***Top Workmanship Quality Issues:***

**Timeframe:** [April 2006](#)

# Americas Top 5 Defects MTD

**Routing Cables:** Fiber cable not secured within the routing clips

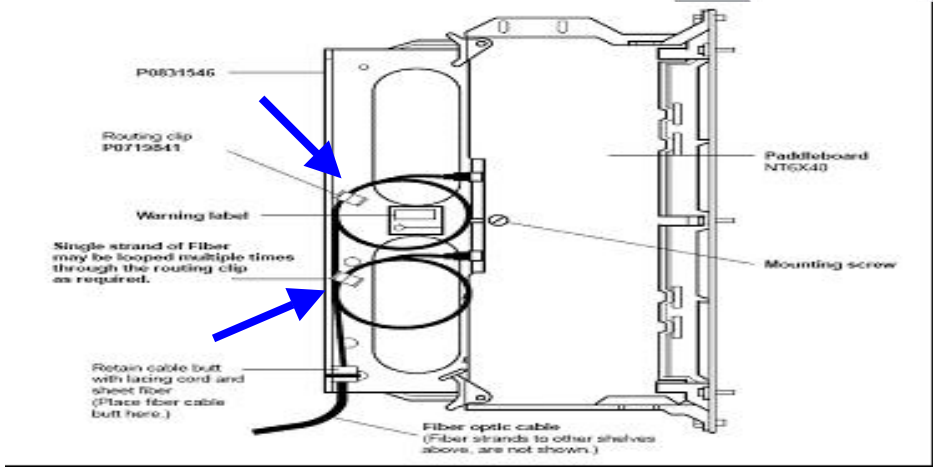
Loose or unsecured fiber patch cords may accidentally be tug or pull by an individual passing or working around the bay.

(Procedural Non-Adherence) - The Installation team was not aware or did not understand that IM requirements.

**Correct Method :** Fiber patch cords need to be secured with routing clips of the UFXPM Bracket IM 03-9059 Fig 409.

**Securing Cables:** A2 & B2 power cables have been incorrectly routed to the left rear of the BIP.

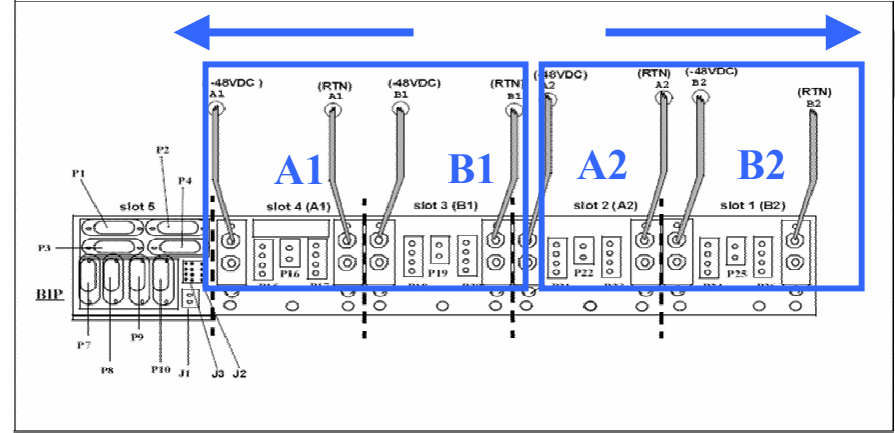
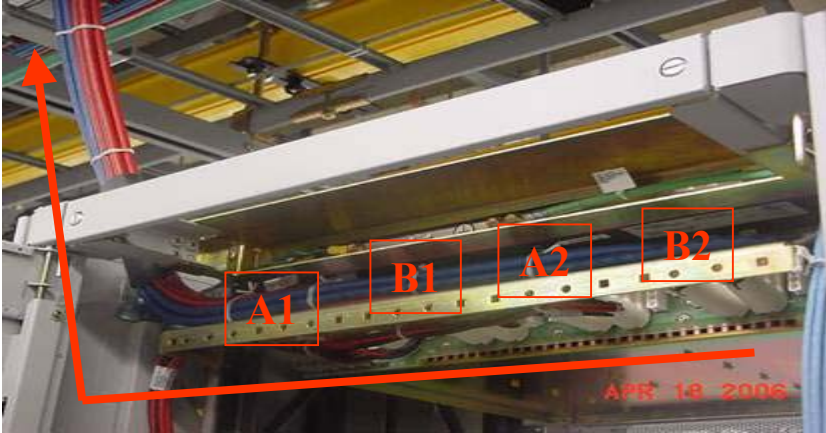
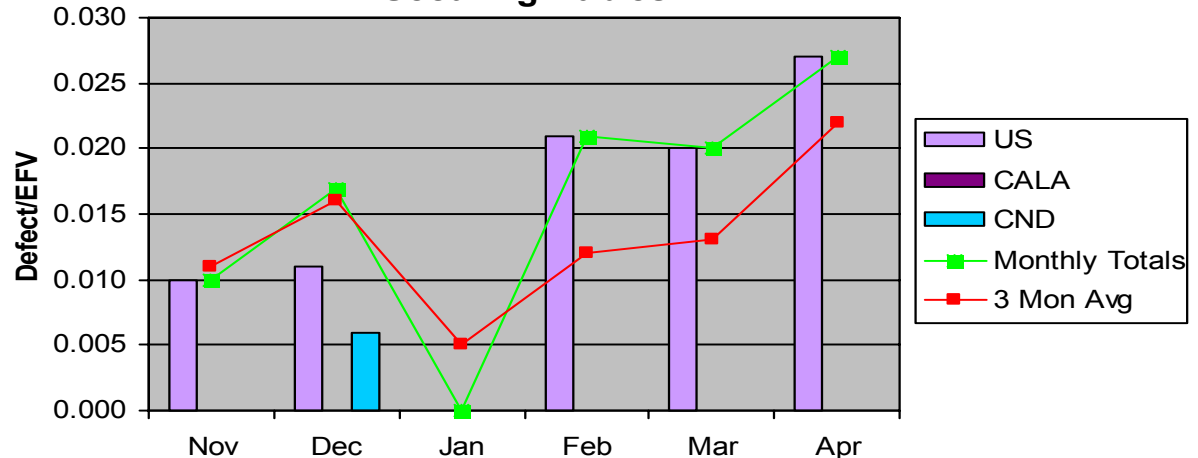
This will lead to inconsistency and cable congestions at the top of the frame.

(Training) – The technician was not aware that this was an IM requirement; however, proceed to install the power cables as per the previous footprint of the office.

**Correct Method :** As per the IM08-1543 section 4.8. A1 & B1 power cables are to be into the top of the frame on the left rear. A2 & B2 power cables are to be into the top of the frame on the right rear

**Fusing :** Guard fuses not installed within the fuse holder.

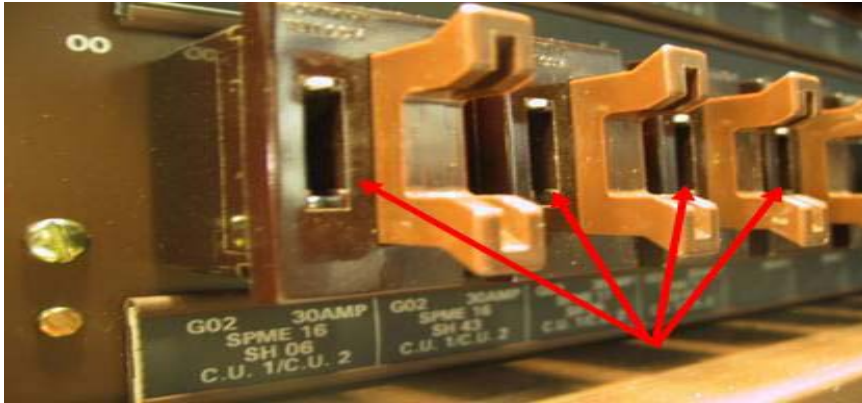
- This can result in not being able to determine which fuse cartridge may have been fused without the indication to the guard fuse indicator.

Installation team did not adequately communicate or log outstanding work for the next shift team to complete the job.

**Correct Method:** Guard fuses are installed as per IM 22-0162, section 3.1 fig 2
